Final Drainage Report

Arvidson Subdivision

Project No. 61049

June 12, 2017

MVE PROJECT 61049
MVE DRAWING 61049-EX-DR-MAP

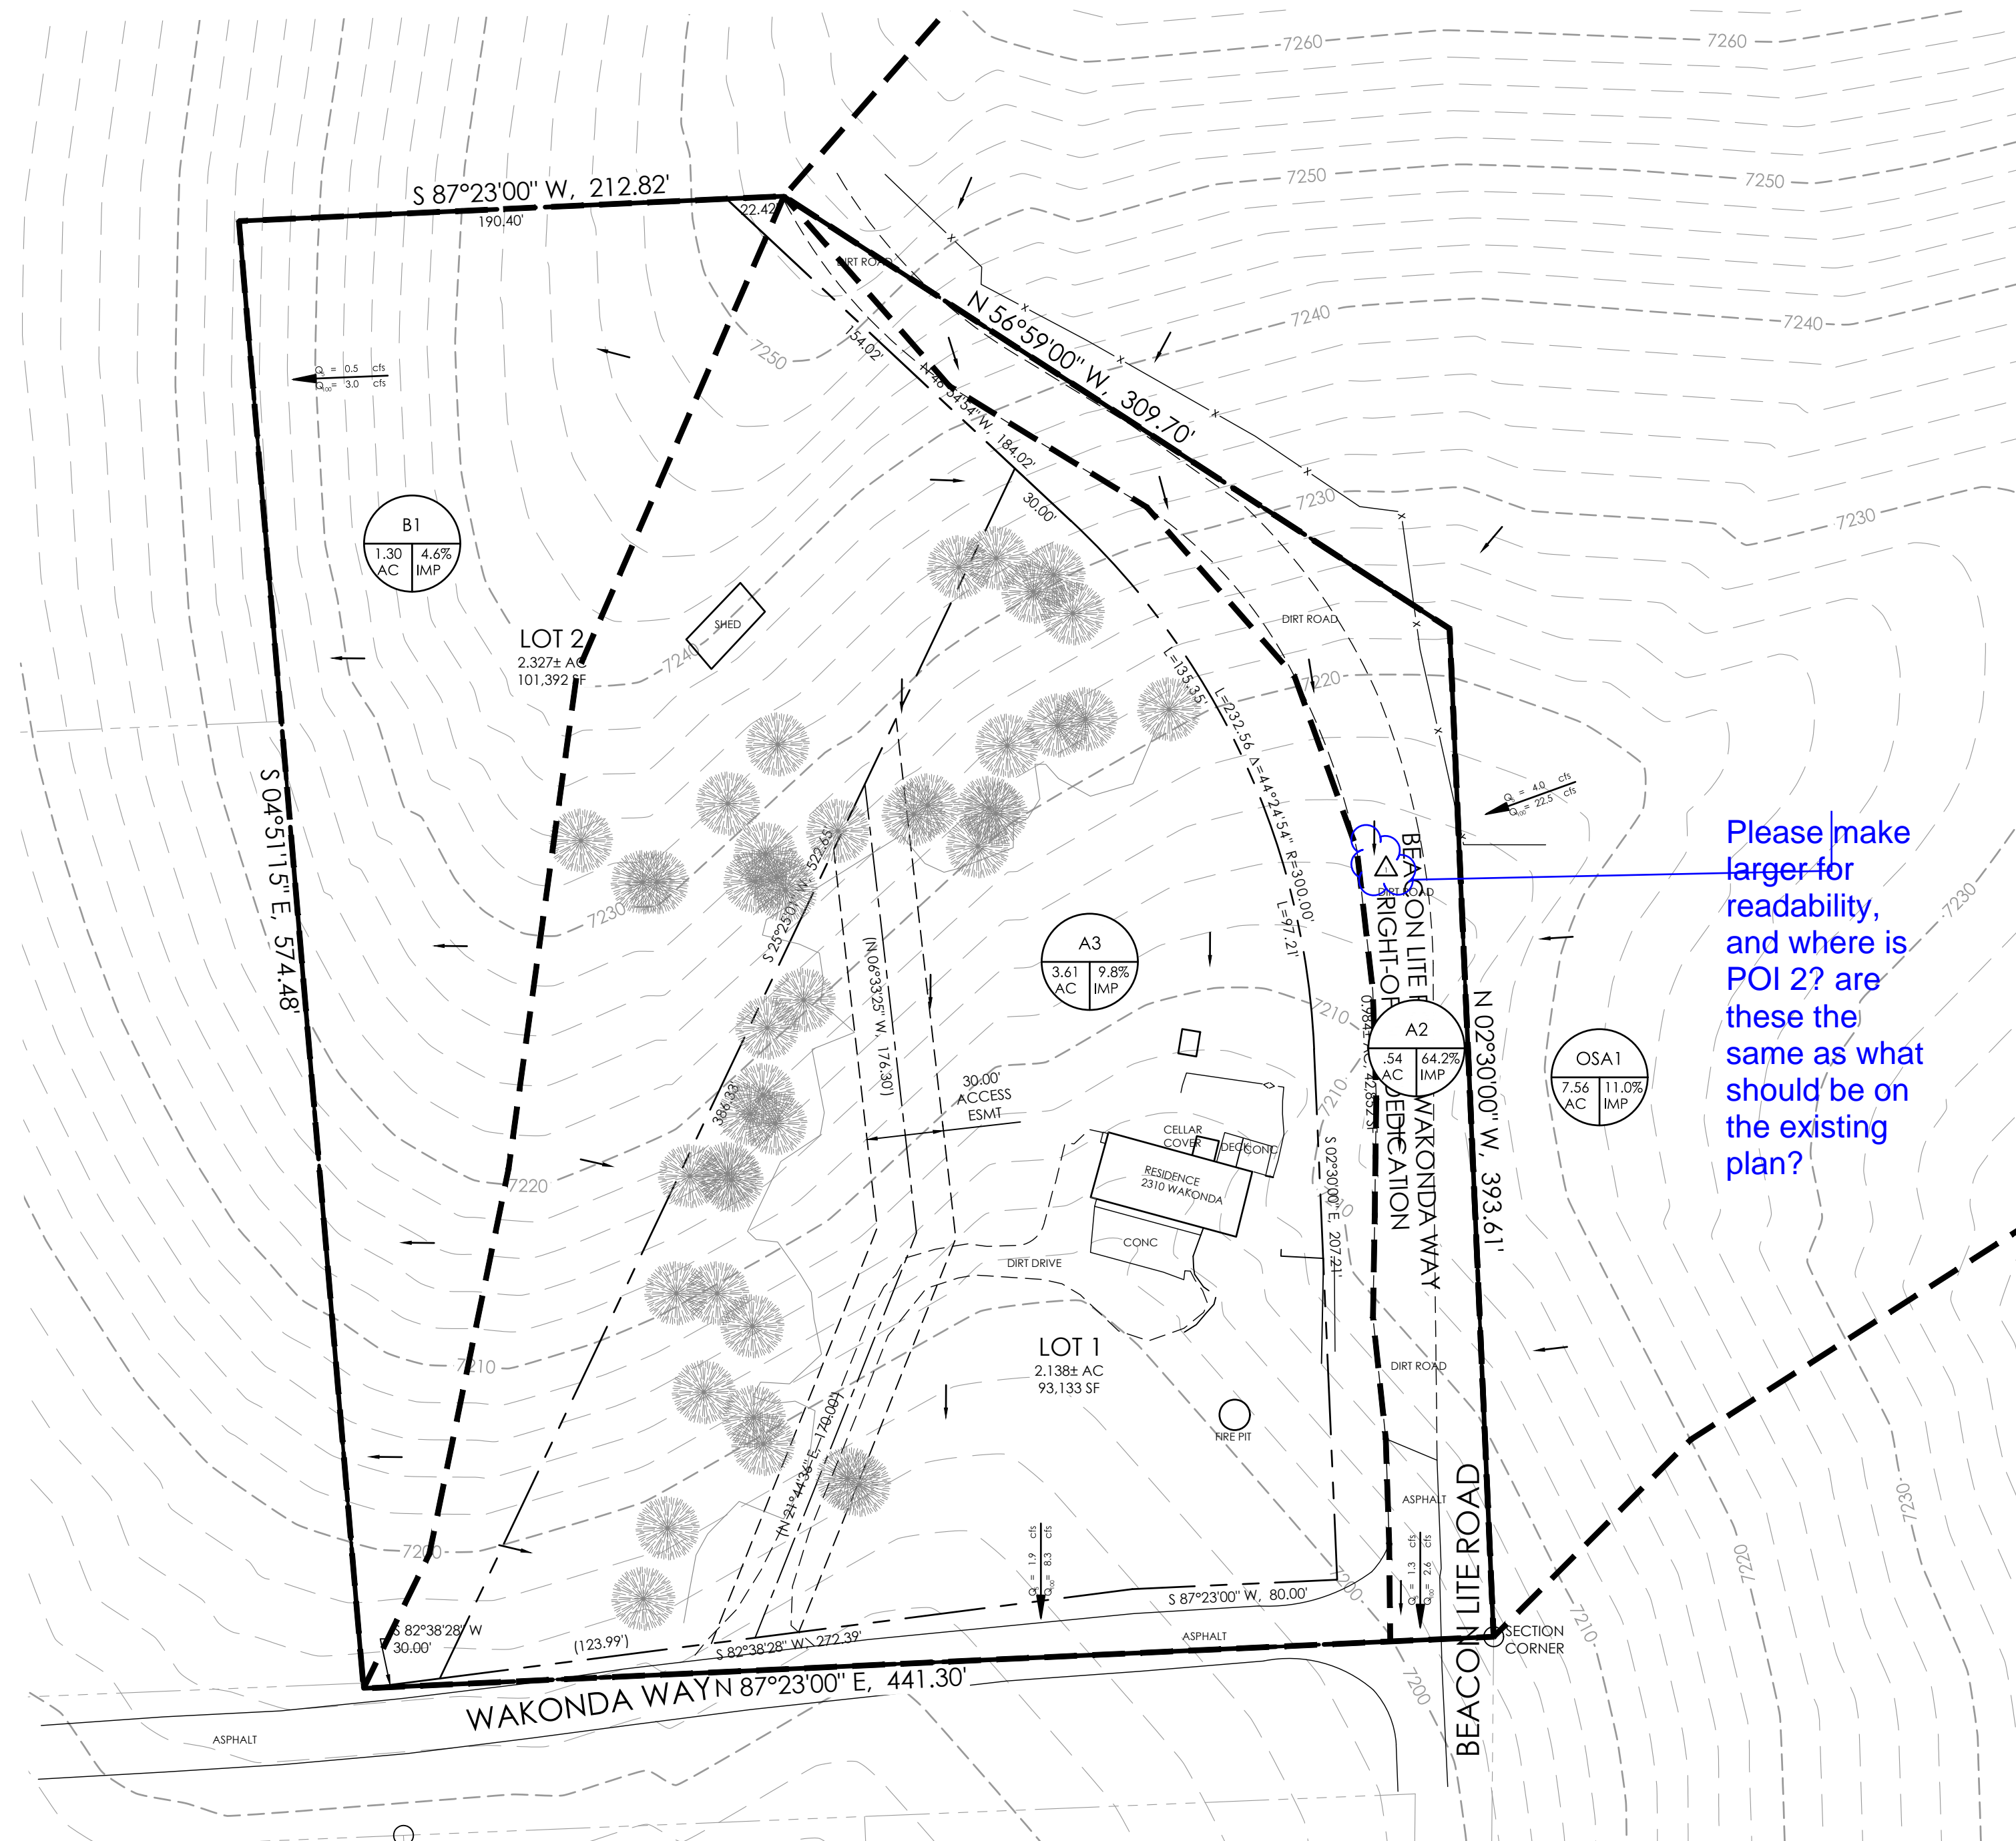
please show on plan

please show ditch as called out on page 3 of report.
